UNITED STATES PATENT AND TRADEMARK OFFICE

APPLICATION NO.	FILING DATE	FIRST NAMED INVENTOR	ATTORNEY DOCKET NO.	CONFIRMATION NO.
10/552,027	10/03/2005	Theodorus Suibertus Anthonius Rolf	P/1336-199	6889
2352 7590 05/19/2011 OSTROLENK FABER GERB & SOFFEN 1180 AVENUE OF THE AMERICAS NEW YORK, NY 100368403				
EXAMINER				
KLAYMAN, AMIR ARIE				
ART UNIT		PAPER NUMBER		
3711				
MAIL DATE		DELIVERY MODE		
05/19/2011		PAPER

Office Action Summary**Application No.**

DETAILED ACTION

Examiner's markings

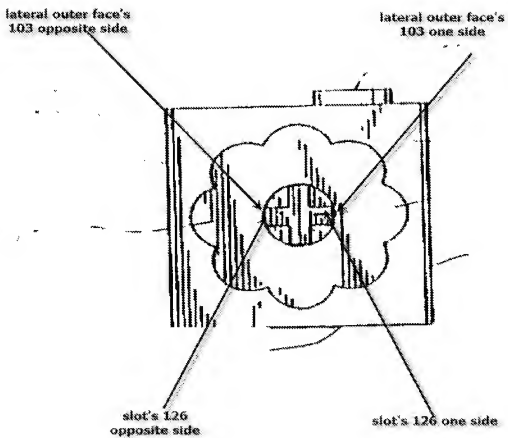
6. Claim 26 is rejected under 35 U.S.C. 103(a) as being unpatentable over Cyrus et al US 6,129,605 as applied to claim 17 above, and further in view of Glynn US 5,725,411.

As cited in the previous office action (which is incorporate herein), Cyrus does not disclose at lest one slots penetrating a lateral outer face for holding edges of construction devices. Glynn was added to show a block (100) having lateral outer face (103) with at least one penetrating slot (construed as recessed connection means (126)) configured to hold edge of construction beam (105) as best seen in figs 6a-6h and discussed in column 4, line 50 to column 5, line 42 (see the examiner rational to modified Cyrus with the teaching of Glynn as discussed in section 4, pages 10-11, in the previous office action). With respect to the added limitations "...at least one slot penetrating the lateral outer face from one side of the lateral outer face to an opposite side....", the examiner will marked Glynn's block to show that slot (126) is penetrating lateral outer face (103) from one side of the lateral outer face (construed as the right side of slot (126) positioned on the right side of outer face (103)) to an opposite side (construed as the left side of slot (126) positioned on the left side of outer face (103)).
